AMENDMENTS TO THE DRAWINGS:

REMARKS

FIG. 2

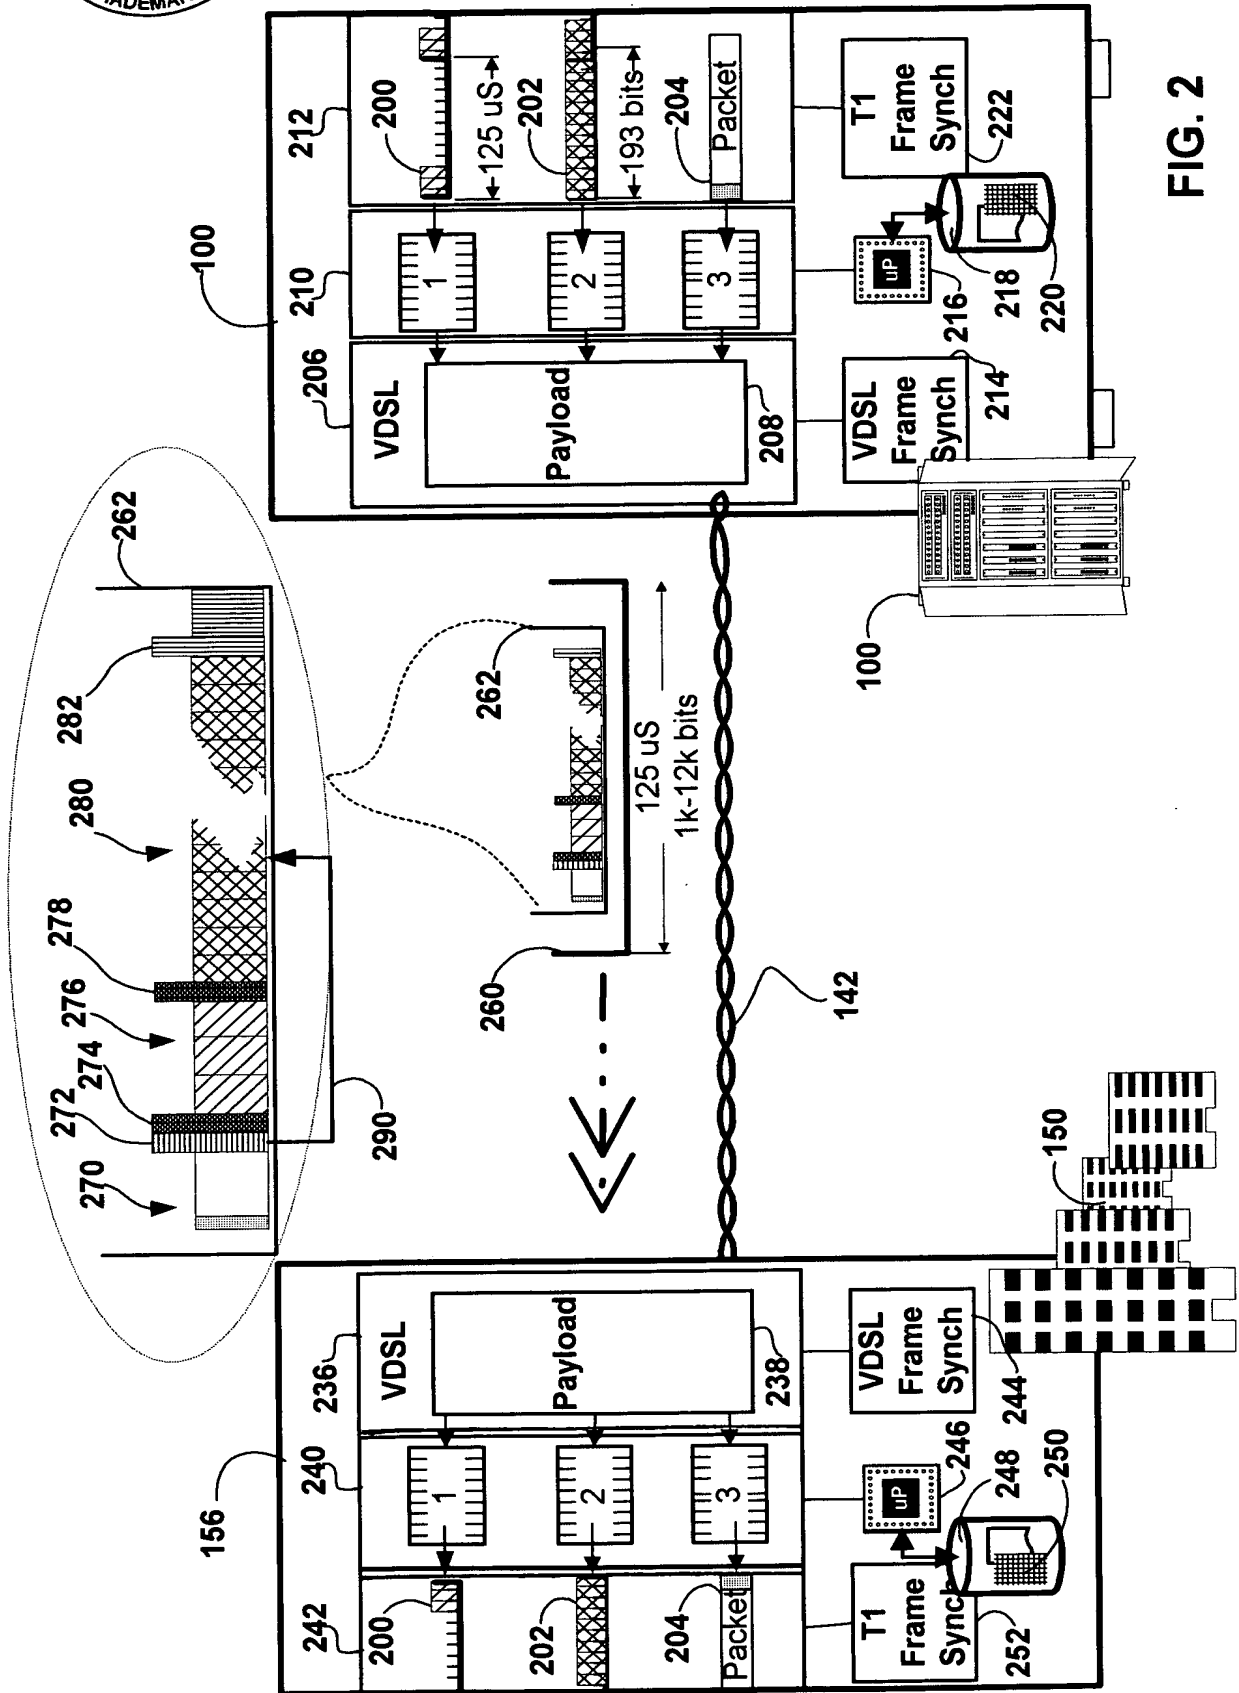
Figure 2 was objected to under 37 CFR 1.84(p)(4) because blocks 236, 240, 242 designated a common block.

Applicant has amended Figure 2 to show the separation of the adjacent vertical sides of the referenced blocks.
